<b>Exhibit 6</b>
<b>4-09-013 (Mariposa)</b>
<b>Surveyed Site Plan with Cross Sections</b>

Re: Modification to the Mitigation Plan for Mariposa Land Company at Malibu Creek.

SUBJECT: CDP# 4-98-024; Lower Malibu Creek West Bank Revetment

SUBJECT: Malibu Creek Vegetation Restoration Plan, CDP# 4-98-024; Lower Malibu  
Creek West Bank Revetment

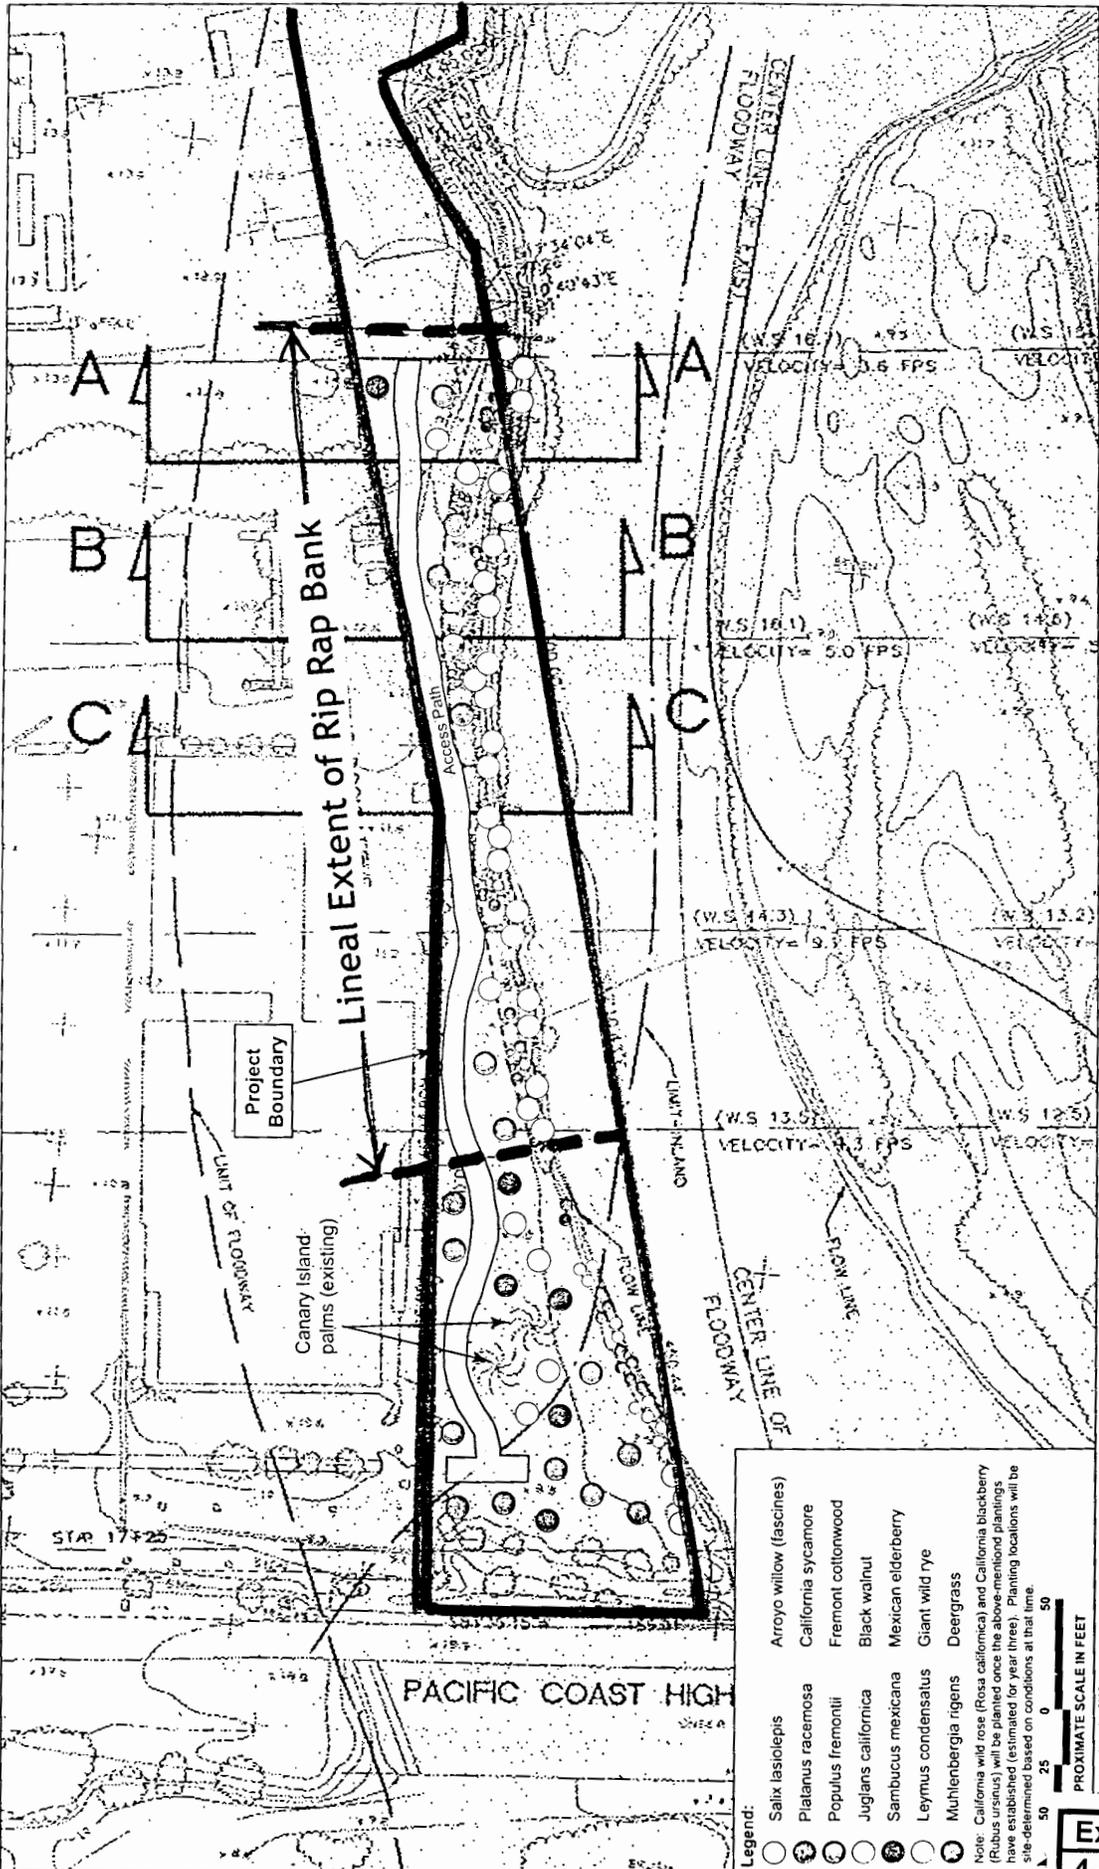
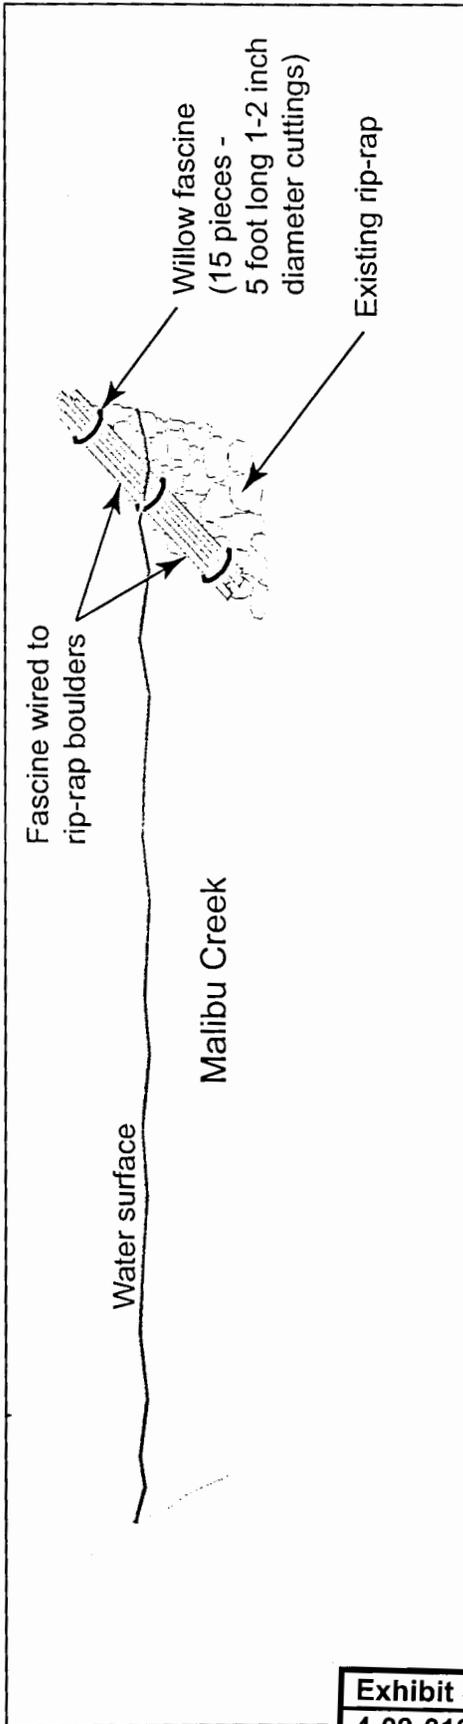
The as-built stabilization is quite steep, approaching 1:1 in some locations. The applicant's engineer asserts that the steepness of the bank stabilization is intended to mimic the natural bank cut that developed on the outer bank of the creek bend. However, this steepness does not readily allow for plants to colonize in the voids between the rocks and, from inspection of photographs of the stabilized bank it appears that most of the bank is void of vegetation.

The current bank and stabilization can feasibly be recontoured to achieve a less steep slope. This would require that the revetment be disassembled from the top, the bank be sloped back, and rock be placed again along the bank at a more gradual slope. The Preliminary Engineering Design Study by PACE (May 25, 2007) asserts that laying the top portion of the existing revetment back at a 2:1 (h:v) slope would result in increased turbidity. But, based the provided information, no evidence has been submitted to support this assertion. There is the potential for some temporary turbidity during construction; however this could be minimized through project scheduling, good work practices and implementation of best management practices. If the revetment were to be reconstructed along the bank at a more gradual slope, a bottom layer of filter fabric should be installed to reduce soil piping and reduce turbidity from high flow events. While it may be necessary to cut root holes into the filter fabric, the soil loss through these openings in the bottom layer would not be significant. Additionally, turbidity should be greatly reduced from the current revetment with rock covering a bare soil slope with no fabric filter layer

at all. The applicant would need to prepare a revised engineering design for the new revetment. Also management plans would be needed to control silt and turbidity and schedule the revetment rebuilding to minimize impacts to coastal resources. Based on all information provided by the applicant, it appears feasible that this slope can be rebuilt at a more gradual 2:1 slope.

Planting Plan

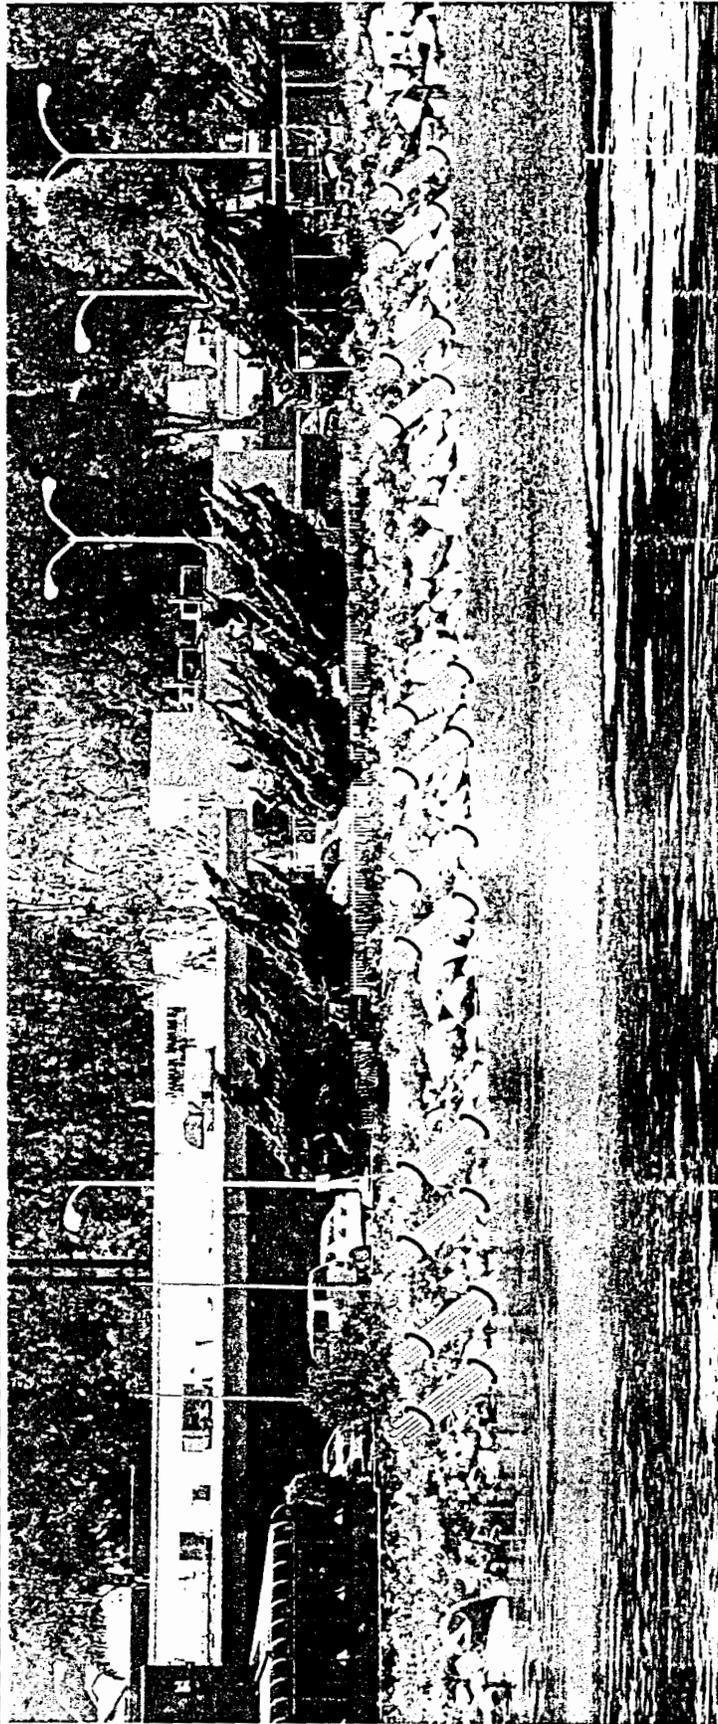
Impact Sciences proposes to modify one aspect of the "Vegetation Restoration Plan - Malibu Creek", the restoration plan that was submitted as part of the application package for Malibu Land Company's pending final permit for bank stabilization along Malibu Creek. Specifically, Impact Sciences now proposes to use willow cuttings, rather than using the willow fascines fastened to the riprap.

Therefore, we propose to modify the plan by eliminating the willow fascines, replacing them with willow cuttings, placed into the interstitial spaces

riprap, and into the soil where the soils is sufficiently moist on a permanent basis. Willow cuttings, which shall be at least one inch in diameter and six feet long, shall be planted at an average of one cutting per eight linear feet (63 - 65 cuttings), with some areas planted more closely than other areas to give a more natural appearance. The exact location of each willow cutting shall be determined by the project biologist.
